# Preliminary Parking Options:

**Application for Amendment to Certificate of Appropriateness #19-48  
Pros & Cons of Accessible Parking Options: Concord Free Public Library**

## Option 1 2019 Approved on Street Parking

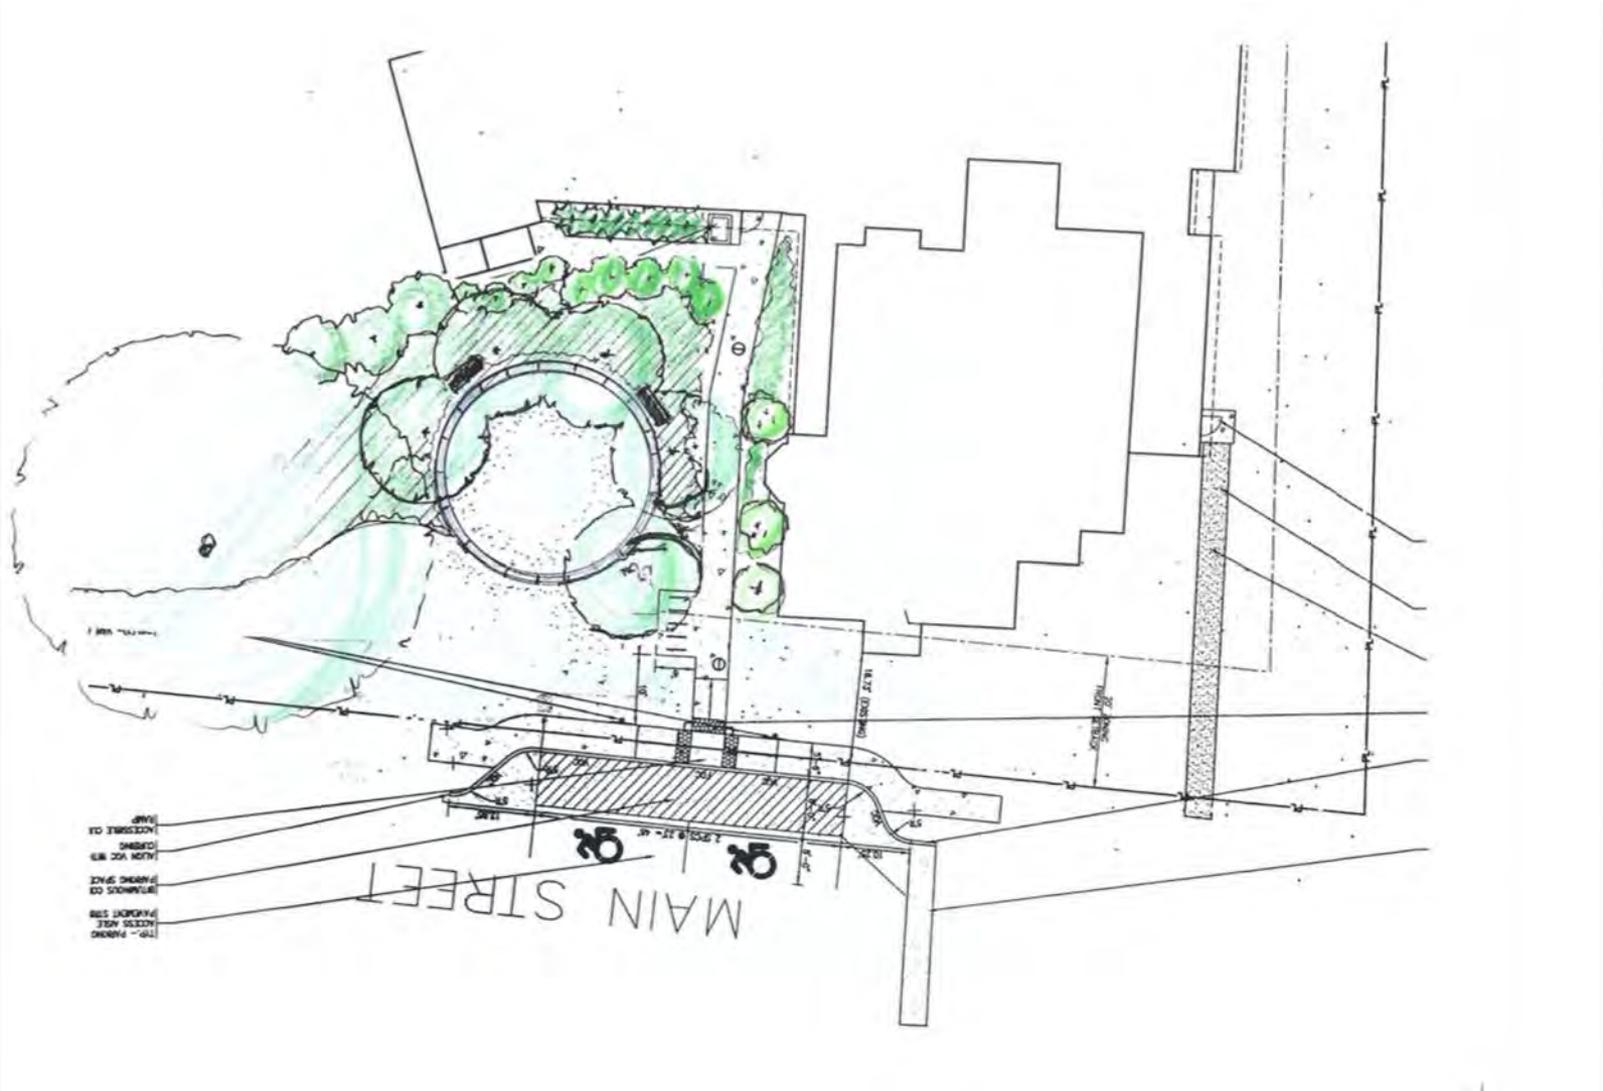
**Option 1 (2 On-Street Parking Spaces approved by HDC and ZBA 2019):**

- Pro's:
  - Large landscaped area
  - Previously approved by HDC and ZBA
  - Net gain of 1 on-street parking space
  - Easier to pull into/out of space without backing into high-traffic pedestrian area by new entrance
- Con's:
  - No buffer between parking spaces and traffic
  - On-street spaces are public (not dedicated for library patrons)

## Option 2 August 2020 Modified On-Street Parking

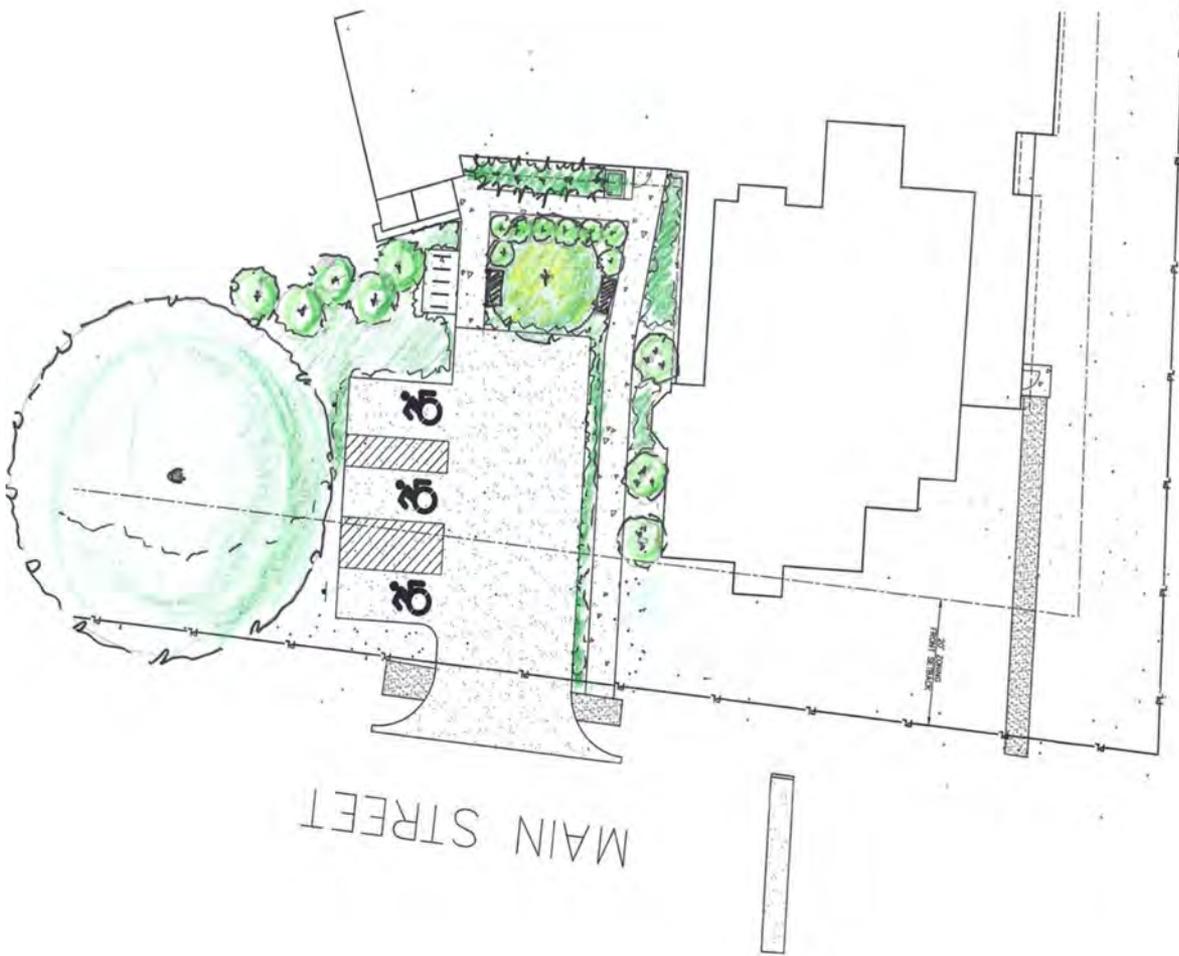
**Option 2 (2 Buffered On-Street Parking Spaces):**

- Pro's:
  - 8 foot buffer between parking spaces and traffic
  - Large landscaped area
  - Net gain of 1 on-street parking space
  - Minimal change from previously approved by HDC and ZBA
  - Easier to pull into/out of space without backing into high-traffic pedestrian area by new entrance
- Con's:
  - Bollards required at flush sidewalk to serve as passenger-side access aisle
  - On-street spaces are public (not dedicated for library patrons)

# Option 6-2 Smith 2020 On Site 2 Car Parking Plan

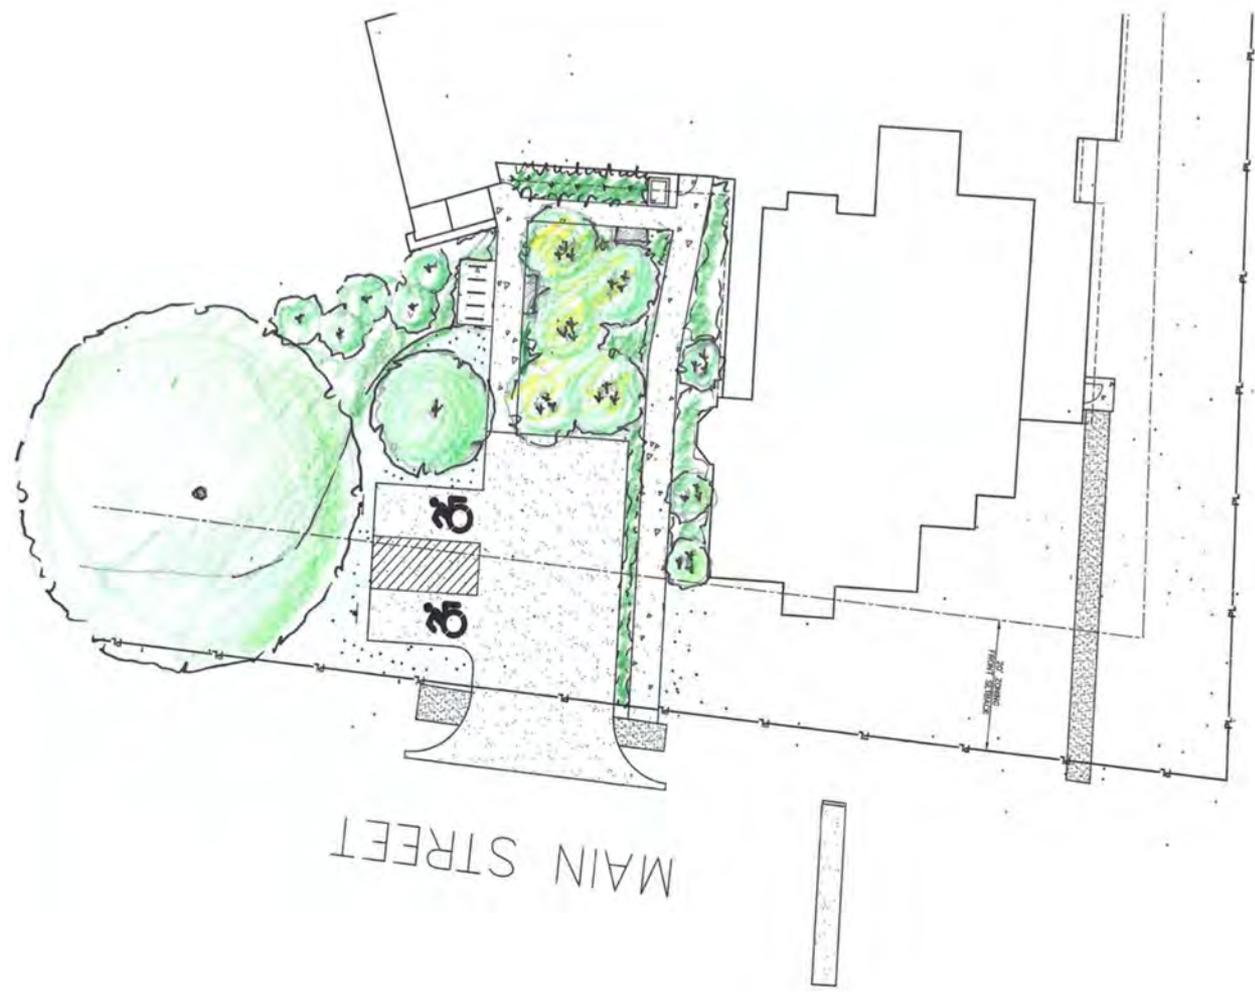
#### **Option 6 (2 and 3 On-Site Parking Spaces Options presented by Sandy Sanford):**

- Pro's:
  - Potential for 3 accessible parking spaces
  - Larger landscaped area between parking area and building than Option 3 in response to HDC comments
  - Potential for access aisles to lead directly to walkway without crossing driveway, depending on grading
  - On-site spaces are dedicated for library patrons
- Con's:
  - Requires relocating driveway and curb cut, and removal of at least 1 on-street parking space
  - Requires relocating utility pole
  - Requires large amount of regrading and removal of granite retaining walls
  - Limited landscaped area compared to on-street options
  - Limited space for landscape buffer between street and parking area
  - Potential impact on large yellowwood tree

- No landscaped buffer between walkway and parking area if access aisles lead to walkway
- Off-street parking requires backing up in high pedestrian traffic area by new entrance
- Difficult maneuvering if vehicle enters when all spaces are occupied
- Headlights would shine toward neighboring residence when pulling into spaces
- Awkward dip in main walkway at each access aisle, if access aisles lead directly to walkway
- Snow would likely be plowed into main walkway

# Option 7 Perry U-Drive

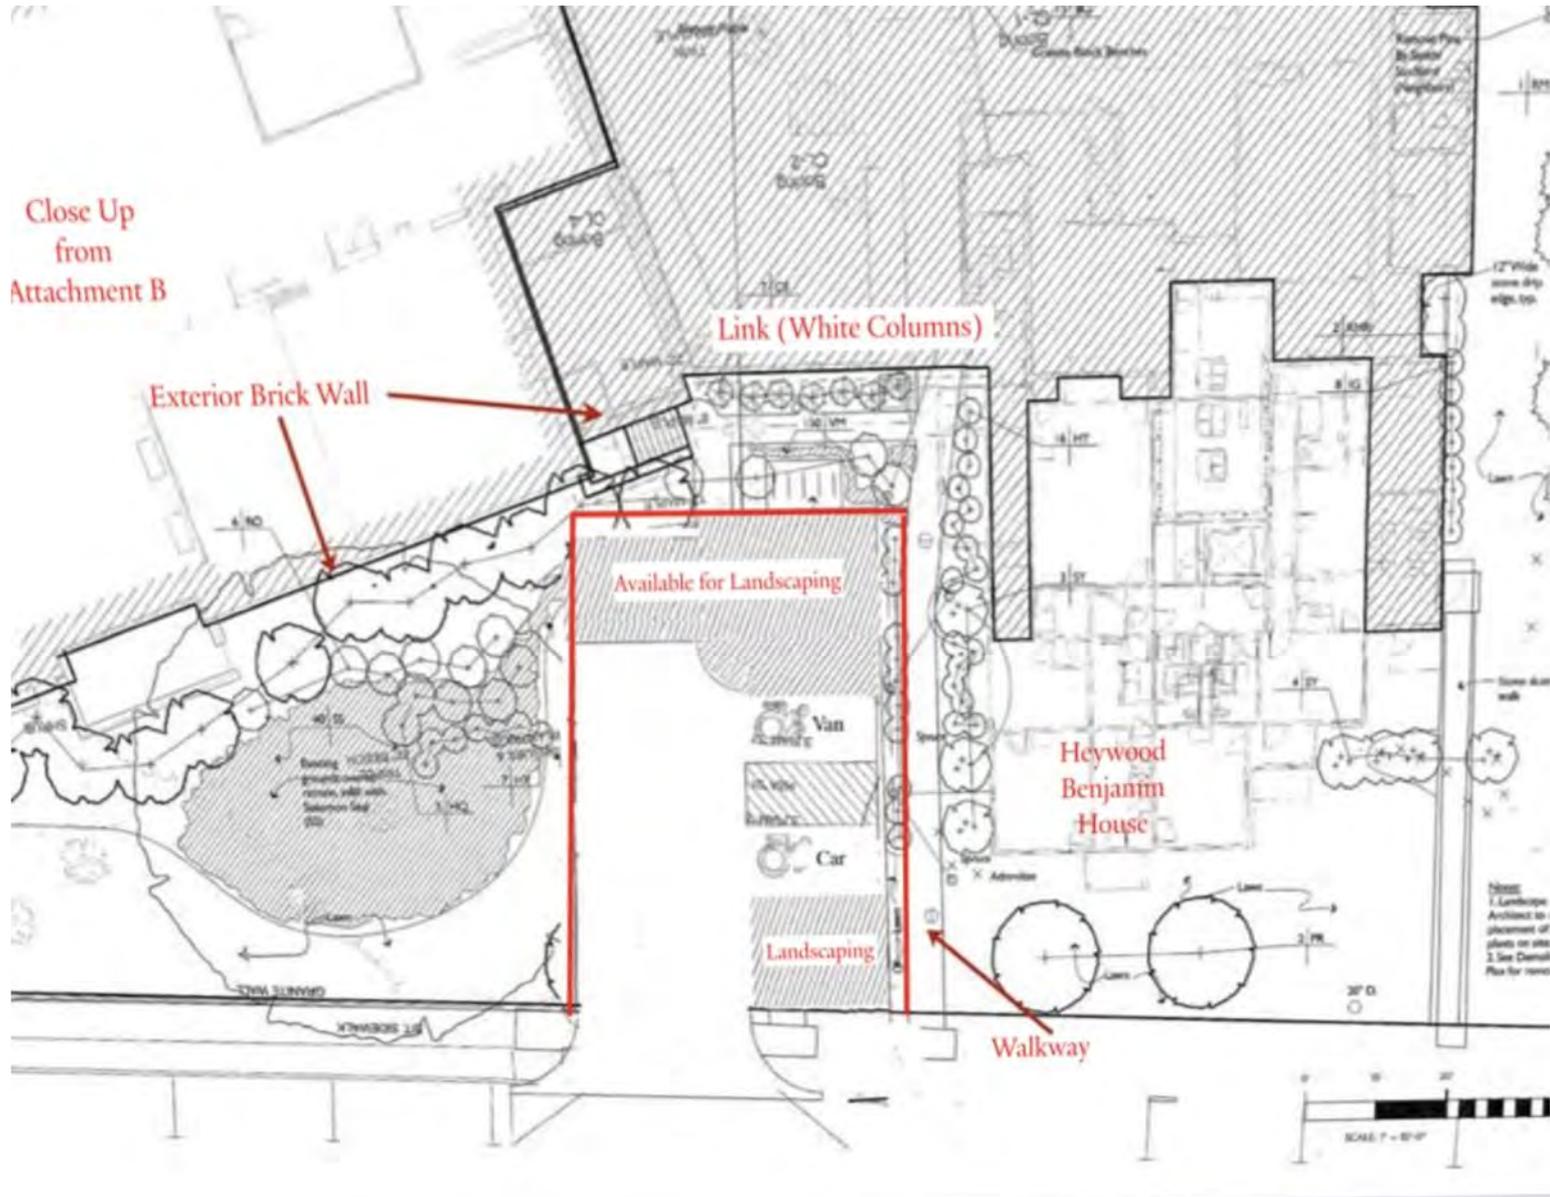
**Option 7 (2 On-Site Parking Spaces with U-shaped Drive presented by Ned Perry):**

- Pro's:
  - One-way driveway eliminates maneuvering difficulties if vehicle enters when all spaces are occupied
  - On-site spaces are dedicated for library patrons
- Con's:
  - Maximum impact on existing landscaping
  - Maximum impervious surface of all options
  - Requires removal of yellowwood tree, whether driveway is 14' or 20' wide
  - Requires relocating driveway, and removal of at least 3 on-street parking spaces
  - Requires 2 curb cuts
  - Requires extensive regrading and removal/relocation of granite retaining walls
  - Limited space for landscape buffer between street and parking area
  - Requires additional walkway to connect parking with new entrance walkway
